**ELECTRICITY INDUSTRY PARTICIPATION CODE
DISTRIBUTED UNMETERED LOAD AUDIT REPORT**

**NZTA HAWKES BAY AND MERIDIAN
ENERGY**

Prepared by: Steve Woods

Date audit report completed: 16 March 2021

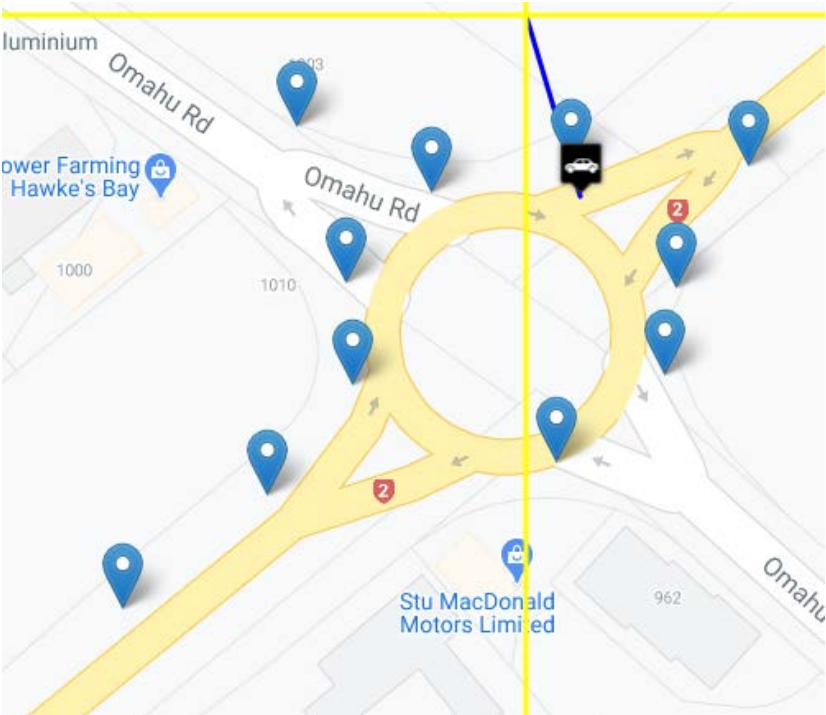
As recorded in the previous audit for ICP 0000939905HB23E, the Burness Road underpass lights are recorded in the database as 3x 36W fluorescent light. These lights have been replaced with an LED panel that is on 24 hours a day (see picture below for reference). It is thought that these are connected to the metered pump supply which is housed at one end of the tunnel. This was being investigated at the time of the previous audit. If these are unmetered LEDs, then a new ICP needs to be created to correctly reconcile this load. The 3 x 36W fluorescent lights should be removed from the database. This is recorded as non-compliance in **section 3.1** as part of the database accuracy clause.

All issues identified have been corrected in the database. The Burness Road lights were identified as metered on another ICP and this is now reflected in the database.		Feb 2021	Identified
Preventative actions taken to ensure no further issues will occur		Completion date
